Report of the Chief Planning Officer

PLANS PANEL EAST

Subject: APPLICATION 10/03042/FU, VARIATION OF CONDITIONS 7 AND 9 OF PLANNING PERMISSION 33/88/02/FU (HARD AND SOFT LANDSCAPING), LAND AT BUTTS GARTH FARM, LITTLEMOOR LANE, THORNER, LEEDS, LS14 3DH.

PROJECT	Littlemoor Lane, Thornor		
TITLE	Landscape Proposals: Southern Boundary		
CLIENT	The Land and Development Practice		
DATE	13 Oct 09	SCALE 1 : 200	SHEET A1
DRAWN	MP/jr	DRAWING NO	2125/1
CHECKED		REVISION	A

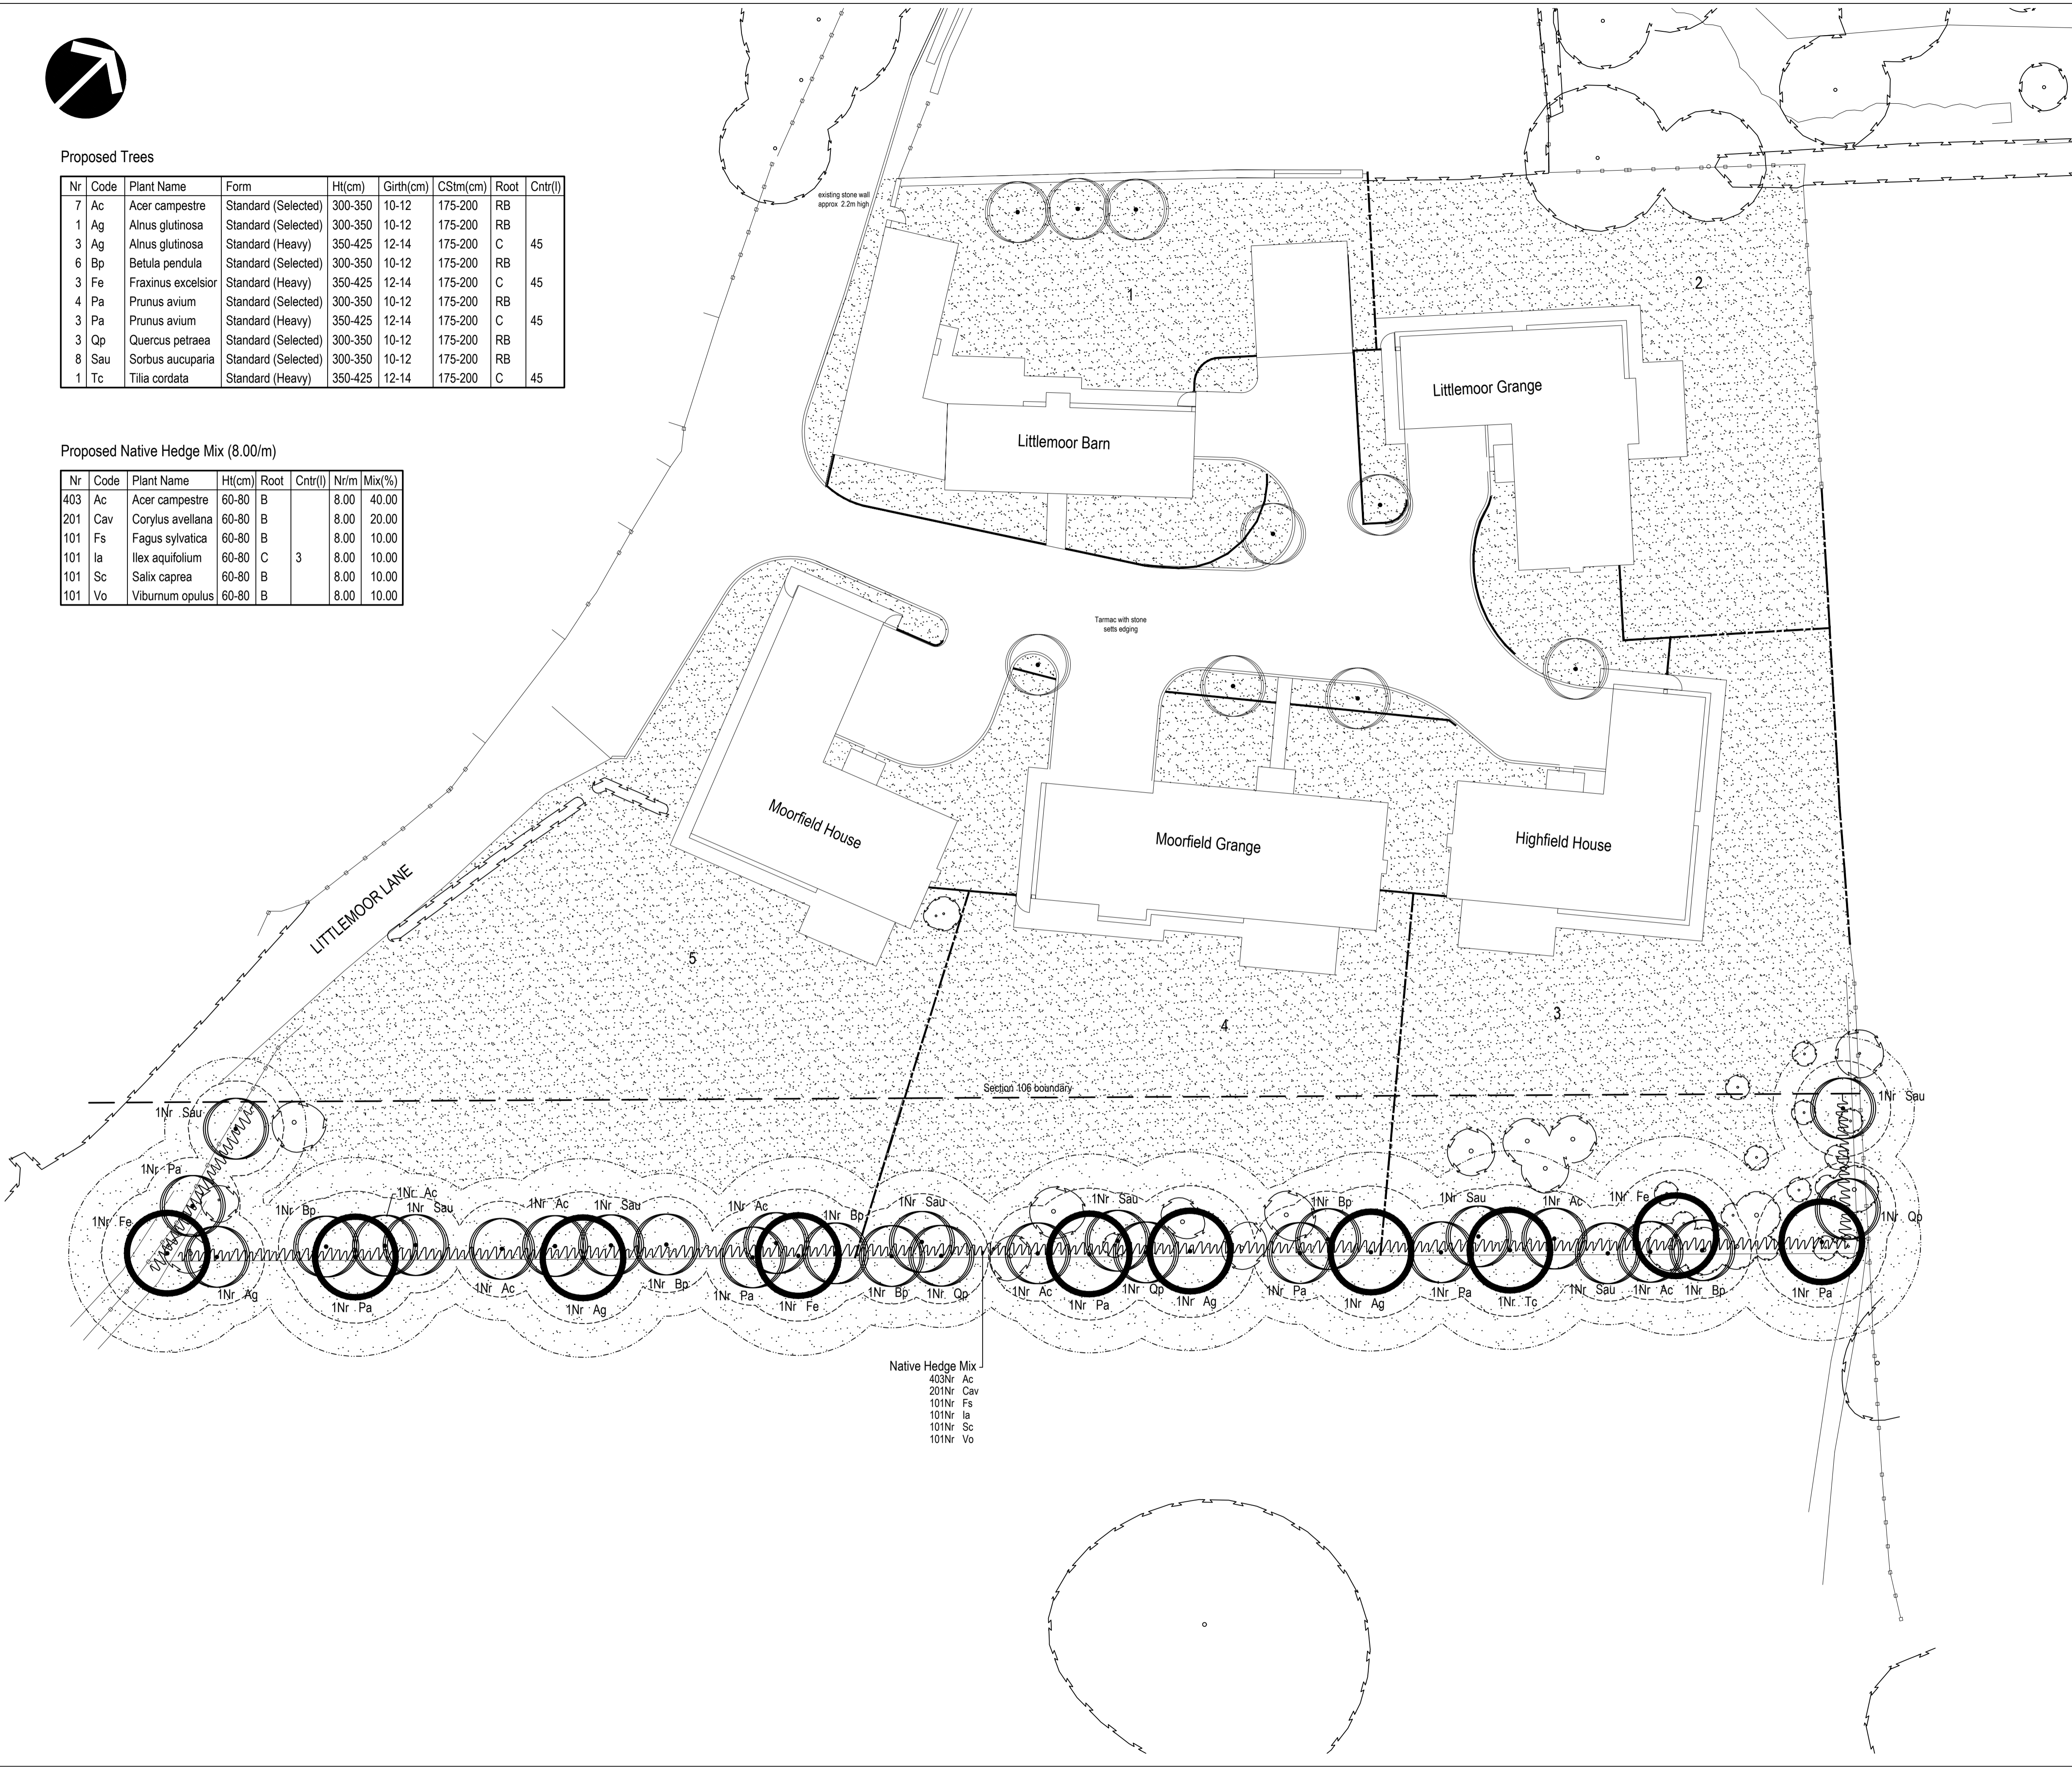
- 10.7. The scheme submitted shows a native mix hedge to the outer boundary with a line of trees planted within it and a return to either side of the site for a distance of 10m. The remainder of the area is grassed with close boarded timber fences dividing the plots right up to the outer boundary. It is not clear whether the beech hedge originally proposed on the side boundary of Moorfield House is to be put in, at the moment a high stone wall forms this boundary.

- 10.8. The impact of this proposal would be:
 - 10.8.1. By removing the inner hedge barrier this area of the site opens up to domestic uses and it allows intrusion of domestic paraphernalia into the green belt and open countryside e.g. garden fences and buildings, play equipment, washing lines etc. This has suburbanising effect which will be detrimental to the openness of the green belt and to the character of this rural area. The change of use of this area of green belt land to domestic use land would be contrary to UDP policies if this were a matter under consideration as part of this application. Regardless of whether there is a change of use, the approved scheme showed no physical access to the buffer zone so there would have been very limited opportunity to introduce domestic elements into this area.

- 10.8.2. The proposed landscaping fails to achieve a suitable buffer. The plans show predicted canopy spreads at 5 and 10 years, these are considered very optimistic and indeed would appear to exceed the mature spreads of some of the chosen species. Growth rates depend upon numerous factors such as ground conditions drainage, wind etc. The proposed trees are planted very closely together, which is likely to result in some trees being shaded out and not succeeding. The trees are also all planted in a single line within the hedge. Taking into account the likelihood of failure and the time taken to achieve maturity then it is considered that this would be a very sparse feature with high visibility through into the garden areas etc.

- 10.8.3. The original landscape buffer achieved 10m depth of planting which would have resulted in a series of overlapping canopies, one behind the other. There would have been no gaps with clear visibility through the buffer like there would be with a single line. Even in winter there would have been a screening effect as a result of the density of branches and twigs. The lack of depth in the proposed scheme means gaps between trees will remain even as they grow, with winter foliage loss allowing the visibility of the site to be further heightened. The revised scheme

- 10.8.4. Furthermore the original buffer zone also had an understorey layer of native shrubs which would fill out any gaps below the tree canopies so that the buffer would be filled from ground level to the tree tops. The current proposal is essentially a line of trees and a hedge boundary to a garden. Normally garden hedges are trimmed to a manageable height of around 1.5m for practicality. The result of this would be a clear gap between the top of the hedge and the lower branches of the canopies, with no depth or understorey planting the resulting landscaping is very suburban in nature and visually open.
